PINS REFERENCE: EN020026

Written representation for Submission Reference [REDACTED]

- 1.1. This document comprises a Written Representation (WR) by myself (I/me) as an Interested Party in respect of a Development Consent Order application (“the DCO Application”) for the National Grid (“NG”) Sea Link project (“Sea Link”).

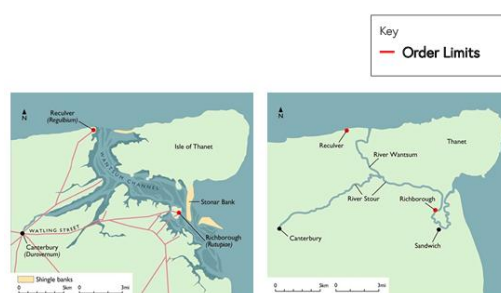
- 14.3. In para 2.7.2 of APP-065 Chapter 5 Appendix 3.5.C Ground Investigation Report – Kent the consultant states “The majority of the Converter Station/ Substation area is identified to be at risk of surface water flooding with the highest risk on site and within 50m of the site being 1 in 30 year return period, depth 0.3 to 1.0m (maximum modelled flood depth)” Have NG just ignored this risk?
- 14.4. Refer also to 2.2 of APP-365 7.11.2 Design Approach Document – Kent that has some of the best maps of the watercourses in the whole pack and shows just how wet the site is now without the need for expensive test boring.
- 14.5. The maps I have taken [Ibid] page 24 show the historic evolution from a wide sea channel. It’s simply the wrong location and goes against their own guidelines and mitigation hierarchy. It will also probably be cheaper if they were to Avoid and choose another site.

14.6.

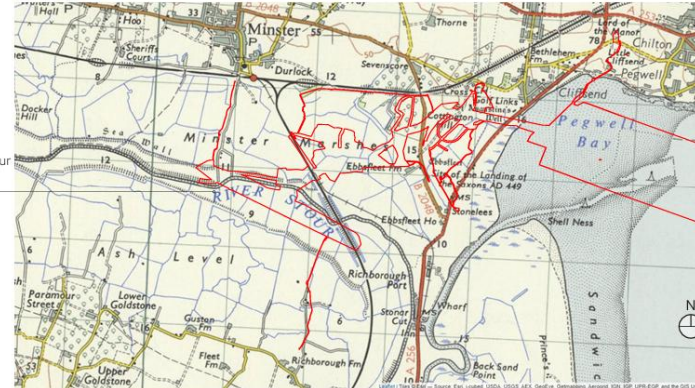
- 14.7. I would query their flood risk data also if their employed specialists have found a problem. Please compare the area maps to the data that can be obtained from the Government's own site that shows the extent of regular flood risk in the area.
- NG's solution appears to be somehow draining the marsh.(see Construction section). Is this factored into their cost calculations? It is not apparent if it is so.
